Re: **Docket No. 495A – Application of Cellco Partnership d/b/a Verizon Wireless for a Certificate of Environmental Compatibility and Public Need for the Construction, Maintenance and Operation of a Telecommunications Facility at 5151 Park Avenue, Fairfield, Connecticut**

Minor D&M Plan Modifications

SITE NAME:
PLATTSVILLE RELO CT

SHEET NUMBER
C-4

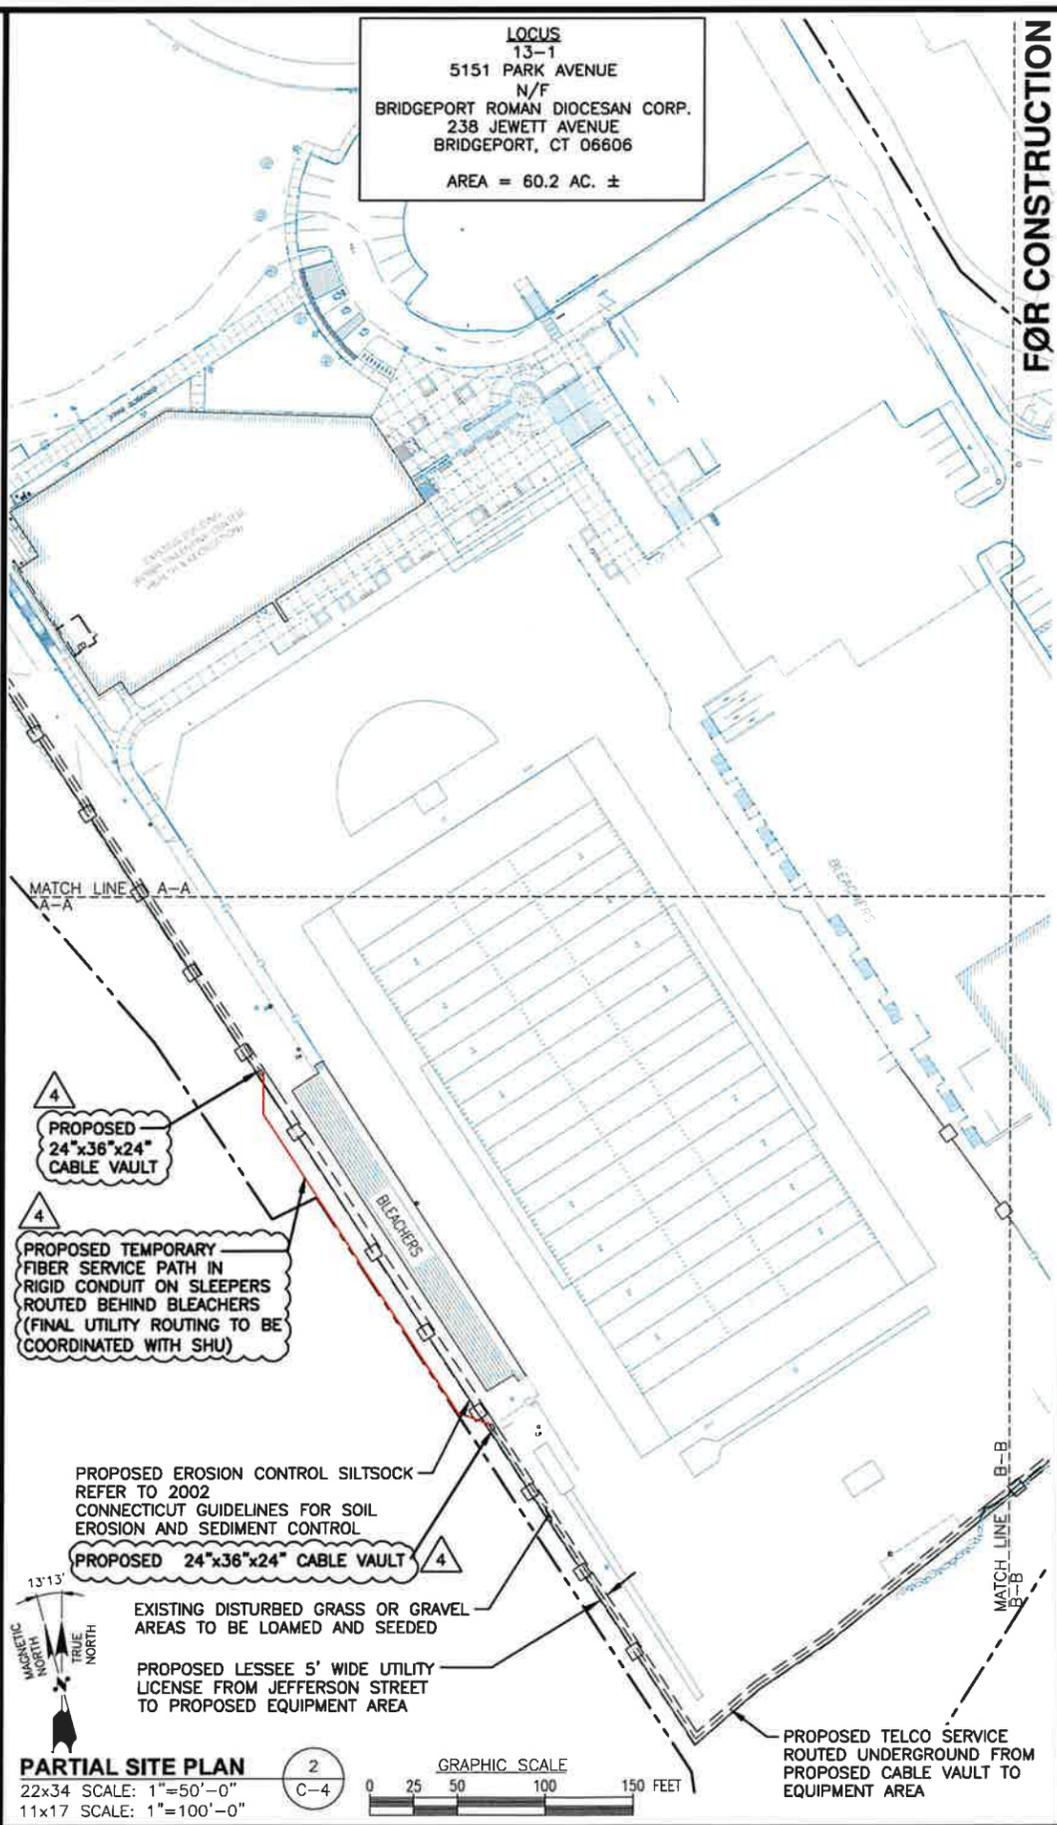
1. Relocate the new utility pole from the Jefferson Street right of way to a location approximately 50 feet to the south along the proposed telco/fiber service route from the existing service along Jefferson Street to the Plattsville Relo cell site. This change was request by Sacred Heart University (“SHU”) to allow for the construction of a sidewalk along the southside of Jefferson Street for students walking between the SHU Main and West Campuses. *See* Construction Plan Sheet C-4 Partial Site Plan attached

2. Install a temporarily above-ground fiber service path in a ridged conduit routed behind the bleachers on the west side of the SHU football field. This temporary change is necessary so that Cellco may activate the proposed cell site with its fiber optic connection while SHU undertakes its plan to upgrade and expand the stadium bleachers in this area. Once the SHU bleacher project is completed Cellco will install the fiber/telco line underground as originally approved in the D&M Plan. *See* Construction Plan Sheet C-4 Partial Site Plan attached.

C-8

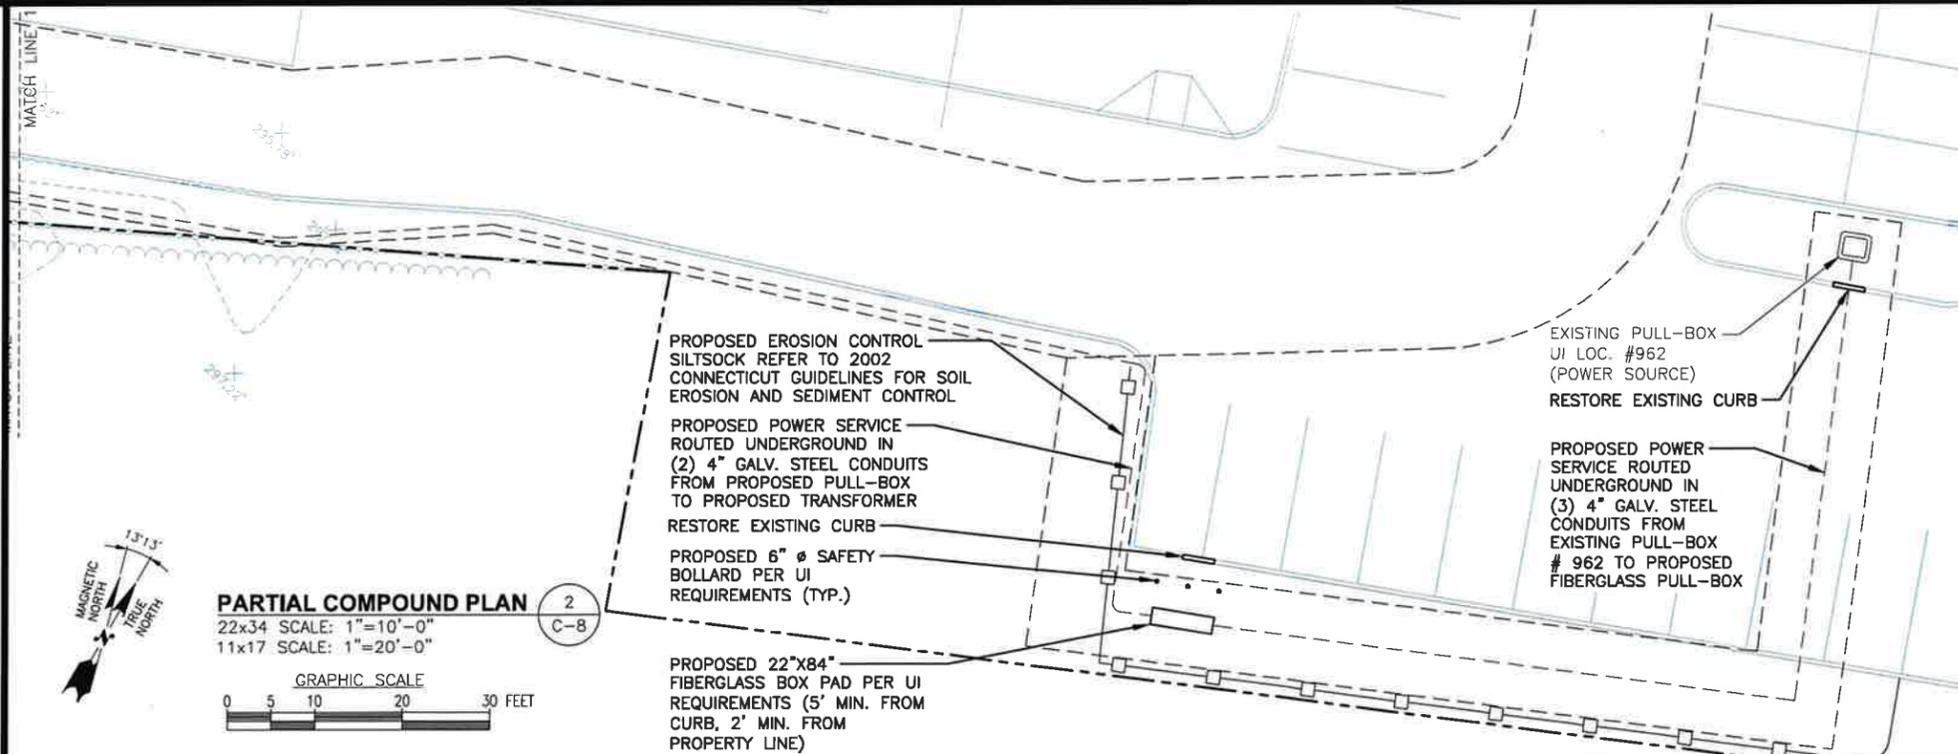
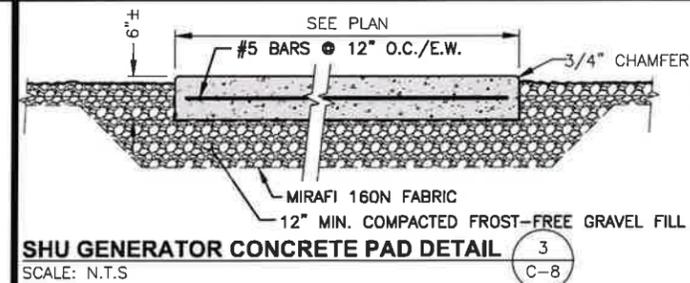
3. Relocate the existing SHU generator from its approved location, adjacent to the base of the proposed tower, to an area to the east of the shared wireless carrier generator. *See* Construction Plan Sheet C-8 Compound Plan attached.

PROPOSED VINYL FENCE (12.4' L.F.)
PROPOSED 7'-8"x15'-0" CONCRETE PAD FOR RELOCATION OF EXISTING SHU GENERATOR (SEE DETAIL 3/C-8)

PREVIOUS LOCATION OF SHU GENERATOR
